Ref: 20018906

5 March 2008

**Bungarribee Precinct: Response to Doonside Submissions**

Figure 1: Pedestrian Network Under Scenario 6

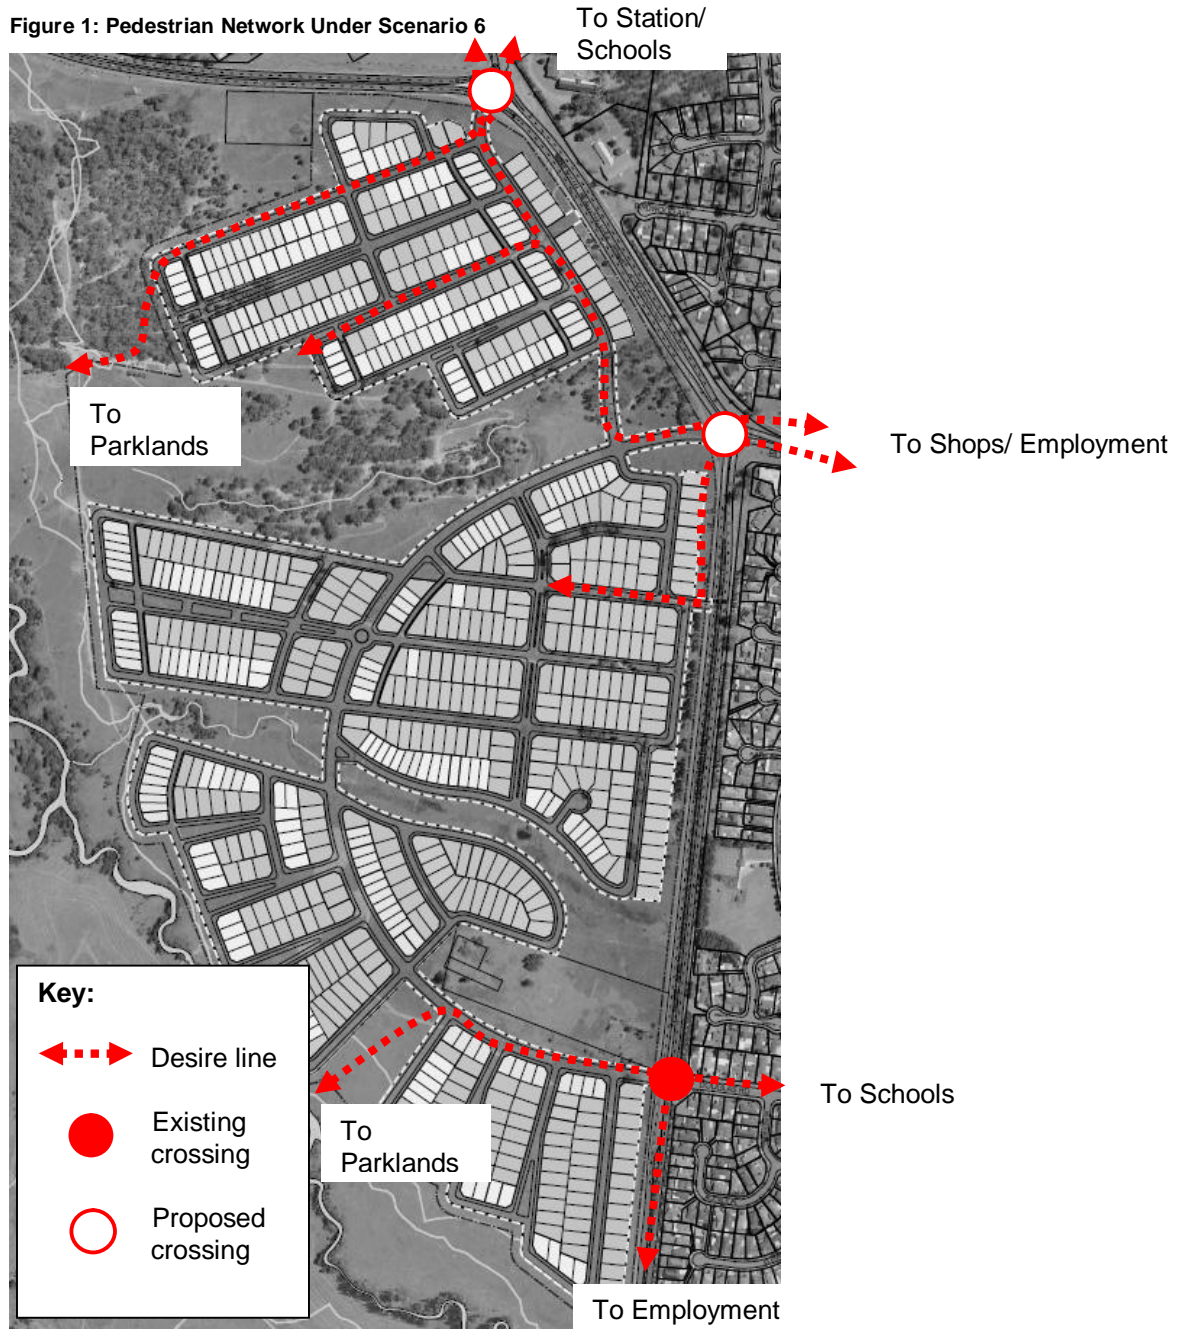
- Mid block pedestrian crossings will not be approved for construction due to safety concerns.
- Signalisation of the intersection of Doonside Road/ Eastern Road is required to facilitate pedestrian movements to Doonside station.

A multi criteria evaluation found Scenario 6 to be the preferred of the nine options as it resolves issues of vehicle delay, pedestrian desire lines, safety and the urban design entry statement. The cost of provision of the two signalised intersections is the single negative factor.

A signalised arrangement at both Doonside Road/ Eastern Road and Doonside Road/ Bungaribee Road would provide safe crossing points for all desire lines, as illustrated by **Figure 1**.
